From: Detterman, Mark, Env. Health
Sent: Monday, January 11, 2016 11:34 AM
To: 'Gary Mulkey'
Subject: FW: Delong Petroleum Site
Attachments: Boring Location Map.pdf

From: Gary Mulkey [<mailto:gary@cci-envr.com>]
Sent: Monday, January 11, 2016 10:51 AM
To: Detterman, Mark, Env. Health
Subject: Delong Petroleum Site

Job No.:	Site Plan 76 Gas Station 1716 Webster Street Alameda, California	Compliance & Closure, Inc.	
Date:		121214-1	
		Drawn by:	Figure No.:
		NLN	1

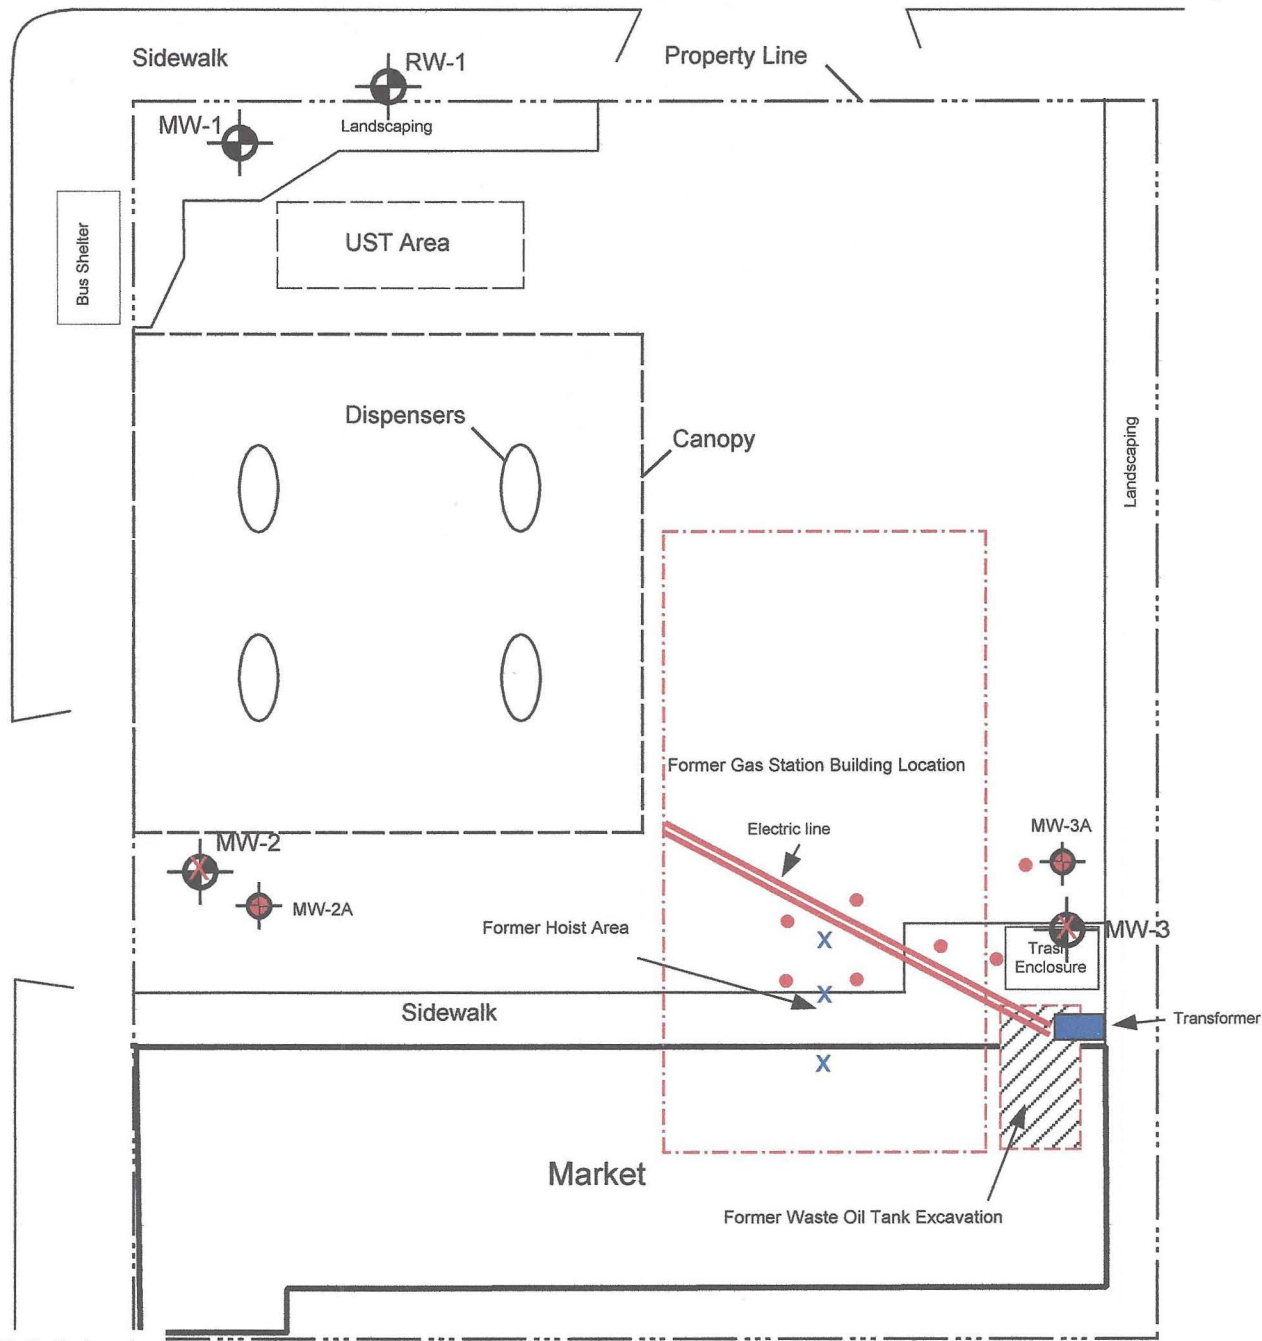
I or ACEH are not tied to 10 soil bores, just a sufficient number to investigate the former waste oil and hydraulic lift areas. The former consultant essentially made that recommendation. The seven look fine, but if anything, I would request / add an eighth soil bore in the landscaping area in the area between the transformer / trash enclosure break to characterize the potential for offsite migration of free phase to a residential property. That is an area I would want to assess either now or in the future, it might as well be now in order to take any "next steps" if they are required. I also note that the November 26, 2014 directive letter requests TPHmo with silica gel cleanup (SGC). To keep consistent with more recent changes in RWQCB SGC recommendations, I should also request TPHmo with and without SGC. To keep costs down a bit, you could run the highest soil sample from each bore for both with and without SGC.
